Title - Sujet Foyer and Classroom Renovation	
Solicitation No. - N° de l'invitation F1700-180006/B	Amendment No. - N° modif. 005
Client Reference No. - N° de référence du client F1700-180006	Date 2018-10-04
GETS Reference No. - N° de référence de SEAG PW-\$PWY-036-8434	
File No. - N° de dossier PWY-8-41046 (036)	CCC No./N° CCC - FMS No./N° VME
Solicitation Closes - L'invitation prend fin at - à 02:00 PM on - le 2018-10-11	Time Zone Fuseau horaire Pacific Daylight Saving Time PDT
F.O.B. - F.A.B. Plant-Usine: <input type="checkbox"/> Destination: <input checked="" type="checkbox"/> Other-Autre: <input type="checkbox"/>	
Address Enquiries to: - Adresser toutes questions à: Martin (PWY), Delia	Buyer Id - Id de l'acheteur pwy036
Telephone No. - N° de téléphone (778) 707-2139 ()	FAX No. - N° de FAX (604) 775-6633
Destination - of Goods, Services, and Construction: Destination - des biens, services et construction: DFO - Pacific Science Enterprise Centre (PSEC) - West Vancouver, BC

This Amendment #005 is raised to Issue Addendum #01.

Project Title	PSEC - CLASSROOM ADDITION AND RENOVATION		DATE: 03/10/2018
	INTERIOR FINISH MATERIAL & COLOUR LIST - Renovation		
	PROJECT F1700-180006		
Rev

1 W/C - WEST ELEV.
A8.00 1:50

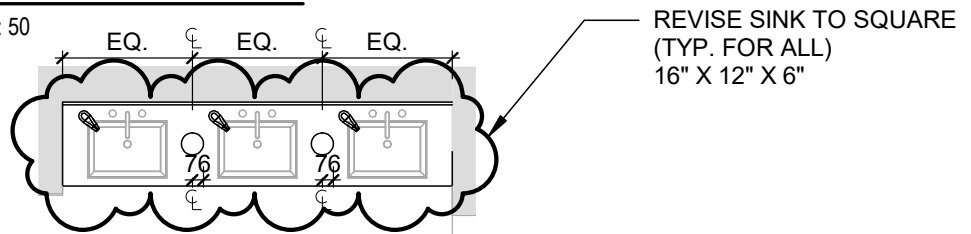
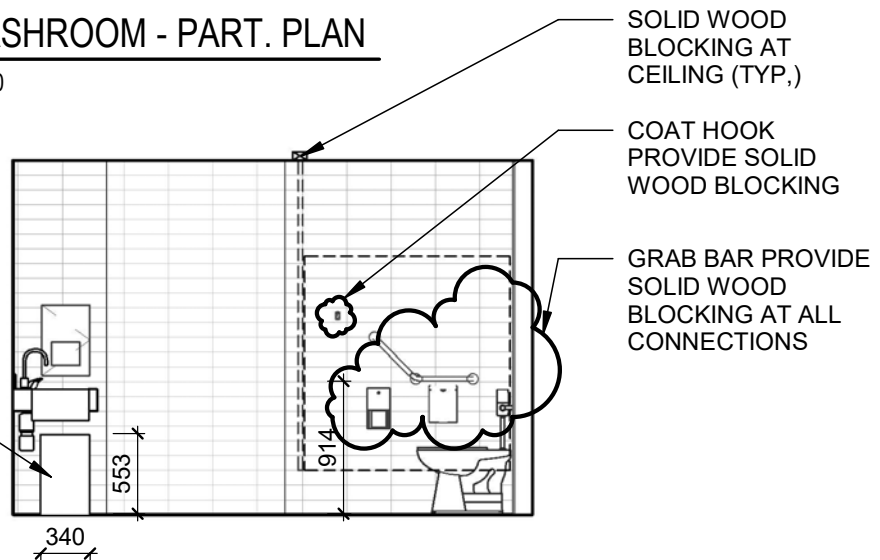
1. REFER TO ATTACHED FINISH MATERIAL AND COLOUR LIST – RENOVATION
2. REFER TO ATTACHED DRAWING ASK#1
3. REVISIONS IN SPECIFICATIONS:
 - a. SECTION 09 51 00
 - Revise part 2.2.8:
 - o Sizes: 600 mm x **600** mm x 19 mm (for metric grid).
 - b. SECTION 10 28 00
 - Delete part 2.2.3
 - Revise part 3.2.3:
 - o Semi-recessed towel dispenser: one in each washroom where indicated. Maximum height of dispenser and operable part from floor 1200 mm.
 - Delete part 3.2.9
4. CLARIFICATIONS TO QUESTIONS SUBMITTED
